## **Mekong River Commission**

### **Procedures for Notification, Prior Consultation and Agreement (PNPCA) Prior Consultation**

#### **In support of Public Consultation regarding Prior Consultation for the Proposed Don Sahong Hydropower Project**

The Mekong River Commission Secretariat  
November 2014

Blue lines = no expected changes, pink lines expected changes in flows

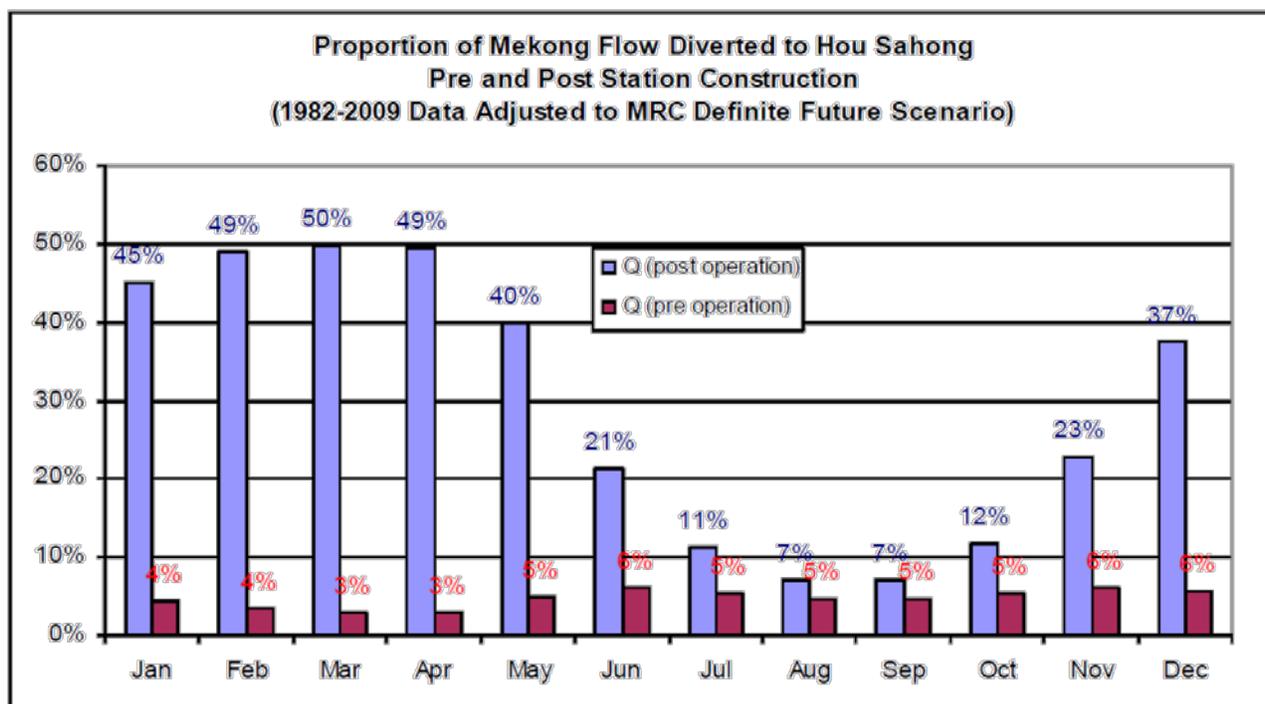
Flows to the west of the Hou Sahong (and DSHP) are not expected to change throughout the year, but the excavation of the Hou Sahong inlet will divert flows away from the Hou Phapheng. Flows into the Hou Sahong will be higher throughout the year, while those in the Hou Phapheng will be noticeably lower in the dry season.

At most, and if the system is operated as designed, some 50% of the flow in the Mekong will be diverted through the Hou Sahong, while a minimum flow of 800m<sup>3</sup>/s will be maintained over the Khone Phapheng Falls.
